# UNITED STATES PATENT AND TRADEMARK OFFICE

APPLICATION NO.	FILING DATE	FIRST NAMED INVENTOR	ATTORNEY DOCKET NO.	CONFIRMATION NO.
10/523,385	02/01/2005	Johannes Otto Voorman	NL 020728	4142

<b>Office Action Summary</b>	Application No.	Applicant(s)	
	10/523,385	VOORMAN ET AL.	
	Examiner	Art Unit	
	Christopher R. Lamb	2627

Amendment in Reply to Non-Final Office Action of May 9, 2006

FIG. 3

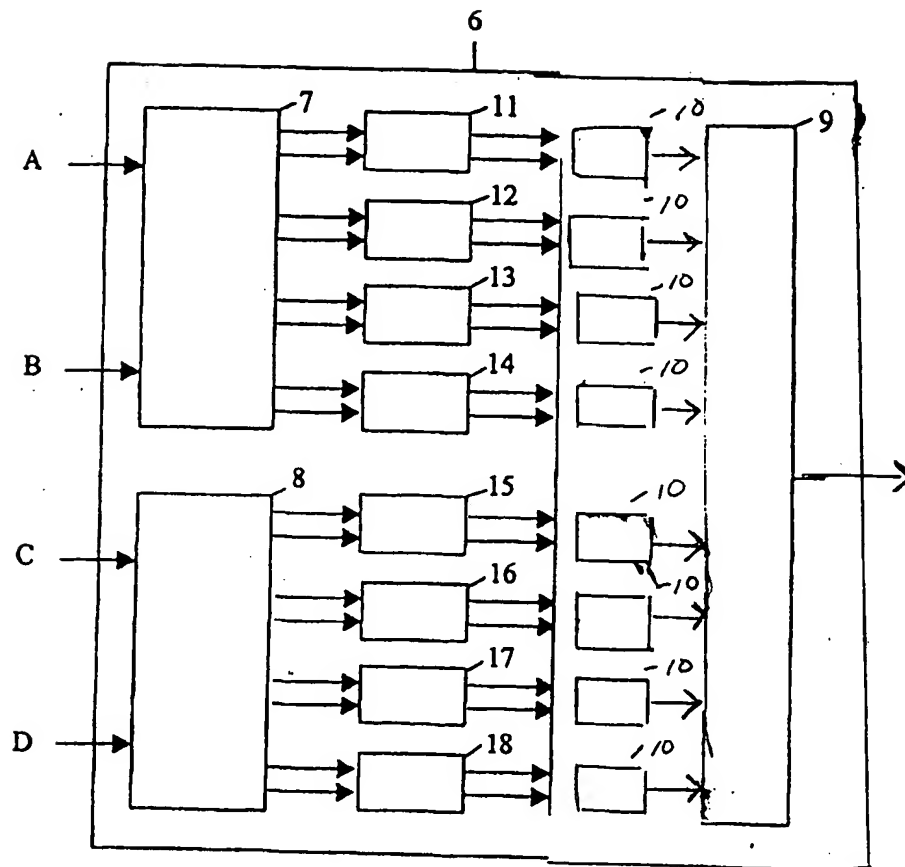
1. The amendment to the drawings was received on August 11<sup>th</sup>, 2006. These drawings are not acceptable.

The new drawing is labeled "Fig. 3." However, there is already a Fig. 3 in the Application.

2. The drawings are objected to under 37 CFR 1.83(a). The drawings must show every feature of the invention specified in the claims. Therefore, the "low pass filter located between at least one sequential-logic circuit and said at least one analog adder/subtractor" (claim 5) must be shown or the features canceled from the claims. No new matter should be entered.

(Note the amended drawing received August 11<sup>th</sup>, 2006 was clearly intended to address this objection: however, because that drawing was improperly labeled, the amended drawing was not entered).

The Examiner acknowledges that the new drawing was intended to respond to the objection to the drawings for failing to show every feature of the invention specified in the claims. However, because the new drawing was labeled "Fig. 3" and there is already a "Fig. 3," the amended drawing was not entered.
